DEPARTMENT OF TRANSPORTATION AND COMMUNICATIONS ONTARIO	
72-11071	
WANAPITEI RIVER BRIDGE	
KING'S HIGHWAY No. 17	DIST. No. 17
DIST. SUDBURY	
TWP. DRYDEN	LOT 9 CON. 3
GENERAL PLAN	
APPROVED	SITE No. 46-124 W.P. No. 36-71-01
DESIGN	CONTRACT No.
DRAWING	DATE
DATE	LOADING

FOUNDATION INVESTIGATION REPORT
For
The Proposed Bridge Site 46-124
Wanapitei River Bridge and
Highway 17
District 17, Sudbury
W.O. 72-11071 -- W.P. 36-70-01

Foundation Report By: P. KORSEMACI
Review of Design Drawings By: A. L. B.
Design Drawing No.'s.: 46-124-P

DEPARTMENT OF TRANSPORTATION AND COMMUNICATIONS	
ONTARIO	
72-11071	
WANAPITEI RIVER BRIDGE	
KING'S HIGHWAY No. 17	DIST. No. 17
DIST. SUDBURY	
TWP. DRYDEN	LOT 9 CON. 3
FOOTINGS	
APPROVED	SITE No. 46-124 W.P. No. 36-71-01
DESIGN	CONTRACT No.
DRAWING	DRAWING No. 46-124-3
DATE NOV. 72	LOADING HS-20-44

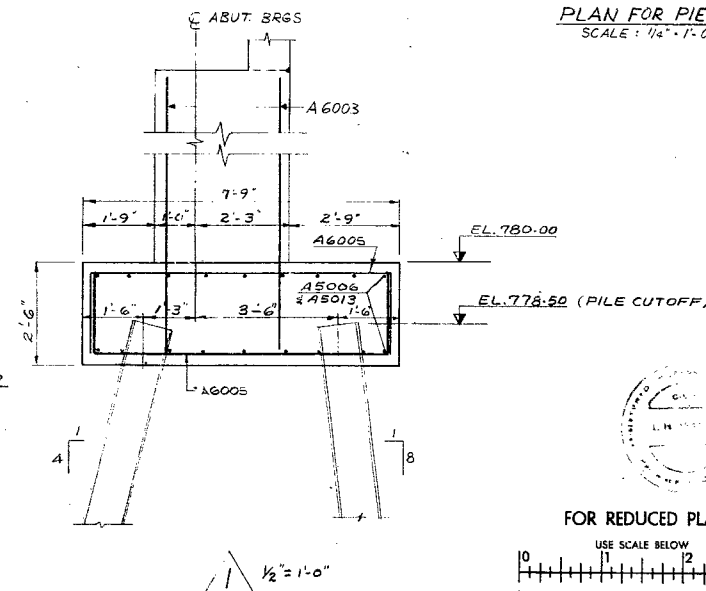
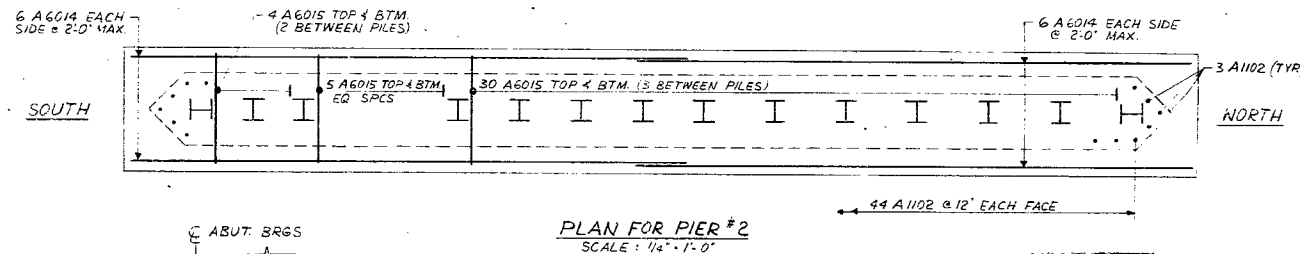
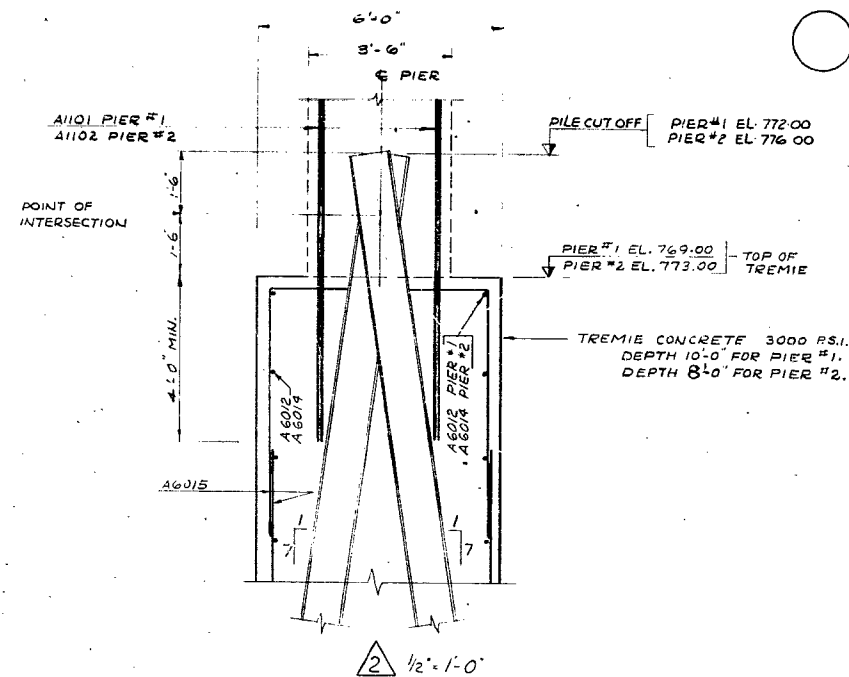
1. Does footing design comply with our report or subsequent memos? YES
2. If answer to 1. is No, is present design acceptable? -
3. Has sufficient field work been done? YES
4. Are estimated pile lengths shown on Drawings correct? If not, make a new list. N.A.
5. If excavation of unsuitable soil is recommended, is this shown on Drawings? N.A.
6. Are approaches designed in accordance with our report? Check slopes and berm lengths. YES
7. Do you anticipate any construction problems? i.e. dewatering, stability of temporary slopes or excavations. NO
8. Summarize your comments; on separate sheet if necessary.

1. Does footing design comply with our report or subsequent memos? YES.
2. If answer to 1. is No, is present design acceptable? A/D
3. Has sufficient field work been done? YES
4. Are estimated pile lengths shown on Drawings correct? If not, make a new list. YES
5. If excavation of unsuitable soil is recommended, is this shown on Drawings? YES
6. Are approaches designed in accordance with our report? Check slopes and berm lengths. YES
7. Do you anticipate any construction problems? i.e., dewatering, stability of temporary slopes or excavations. YES
8. Summarize your comments; on separate sheet if necessary.
